**AMENDMENT NO.8**

**EAST WANNEROO CELL 9 – EAST LANDSDALE**

**AGREED STRUCTURE PLAN NO.57**

**AMENDMENT NO.8 TO THE  
EAST WANNEROO CELL 9 – EAST LANDSDALE AGREED STRUCTURE PLAN  
NO.57**

### PROPOSED ZONING PLAN

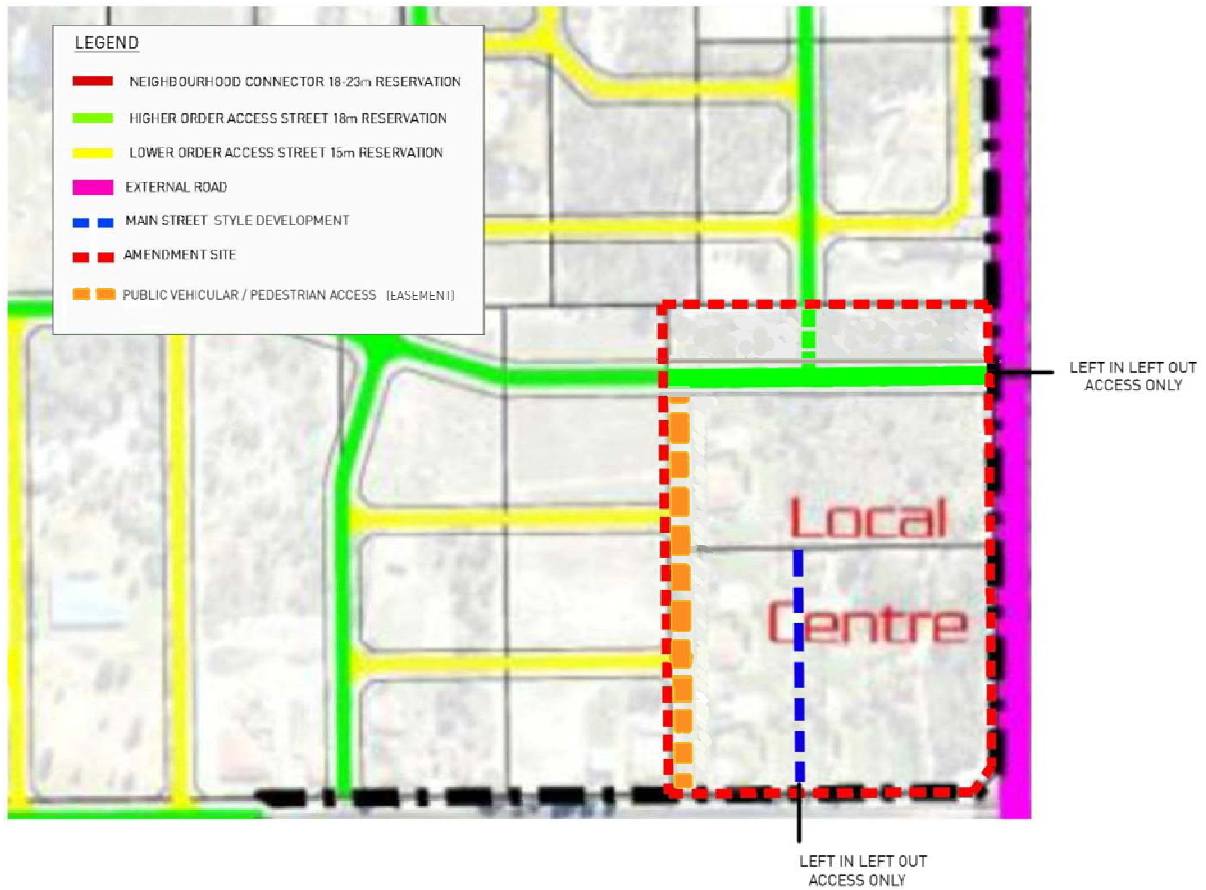
- (d) Amend the LSP 57 Zoning Plan by recoding portions of Lots 154 and 155 Alexander Drive from R20-30 to Commercial and removing the road alignment representations from Lots 154 and 155 Alexander Drive.

### PROPOSED RESIDENTIAL CODING

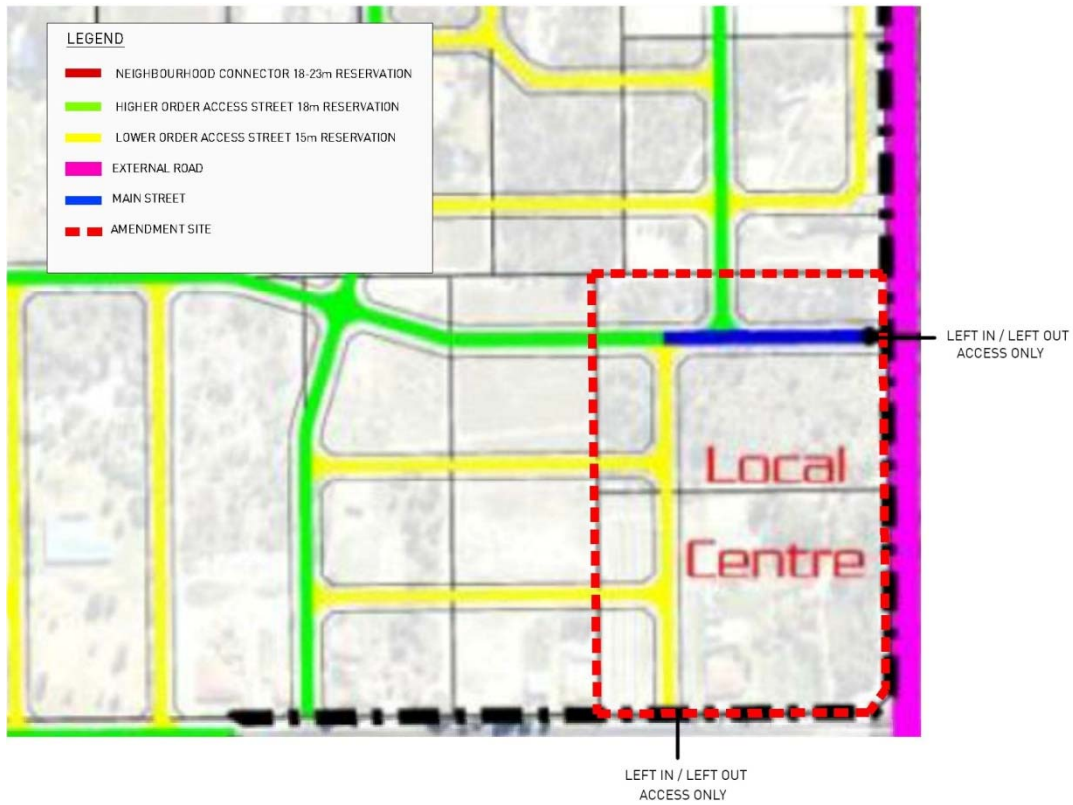
The amendment also proposes to include the entire Commercial site as R20/30 in the Residential Coding plan given that residential development is possible in the Commercial zone and a residential coding is required to provide statutory control and guidance should residential development be proposed in the Commercial zoned area.

**PROPOSED ROAD HEIRARCHY PLAN**

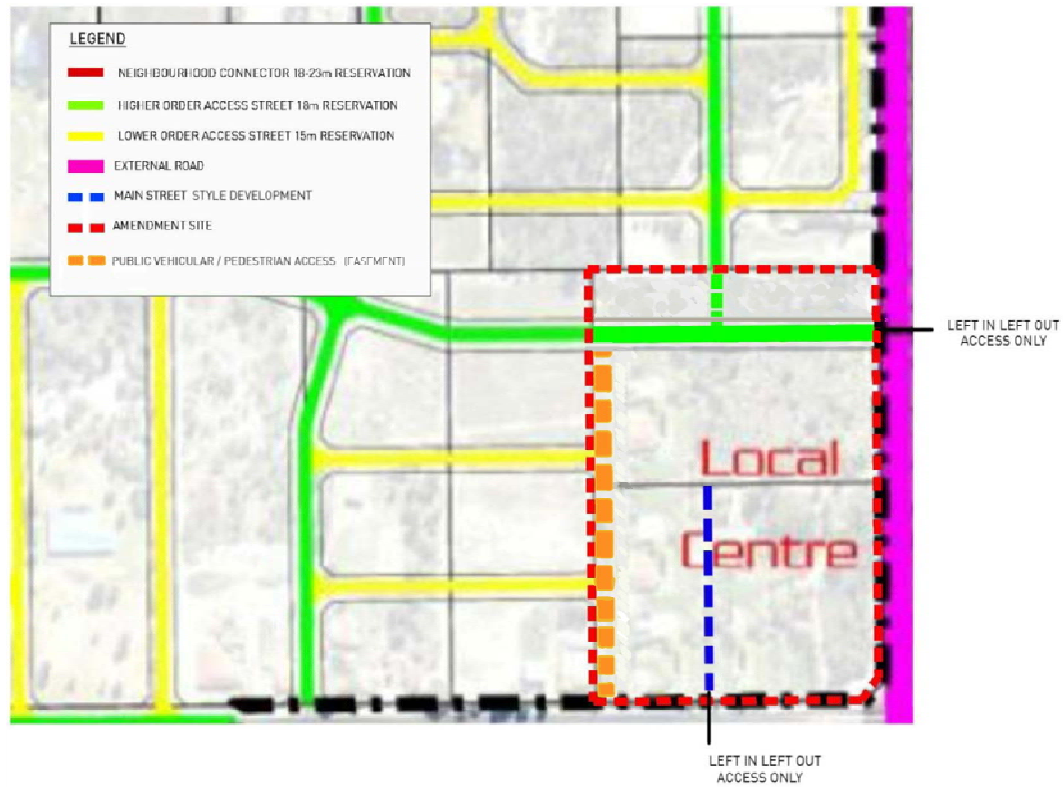
- (e) Amend the LSP 57 Road Hierarchy Plan by removing the road alignment representations, incorporating public vehicular and pedestrian access representations and repositioning the access alignment on the western boundary of Lots 154 and 155 Alexander Drive.
